SOUTHEASTERN DISTRICT HEALTH DEPARTMENT
INDIVIDUAL SEWAGE DISPOSAL INSTALLATION PERMIT

Permit No. _____ Date _____
Installation for Mike Bunch at THE NORTH 660' W 1/2 E 1/2 SW 1/4 SEC 7 T6
(Name) (Legal description of property)
Address of Installation E. Chubbuck Rd. Payette Co. Idaho
No. Living Units 1 Bedrooms 3 People Served 4 Water Supply—Private Public _____ Applicant is: Owner Contractor _____ Other _____
FHA _____ FARM HOME _____ VA _____ CONV. _____ EXISTING NO. _____

Applicant's sketch of house, proposed sewage layout and all adjacent wells (dimension between all components) --

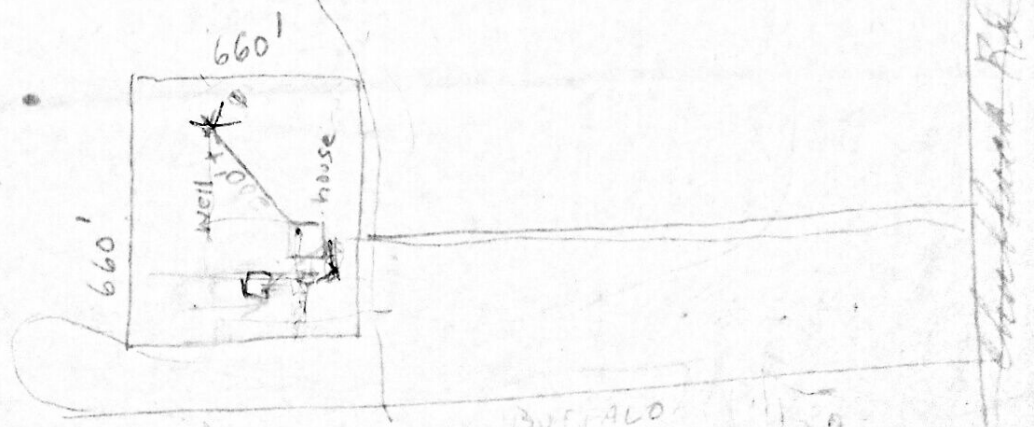
note: will approve (3) 100' drain tile lines or seepage pipe drain field combination to equal (3) 100' drain lines. To be constructed per Idaho Code. Paul Cleaver
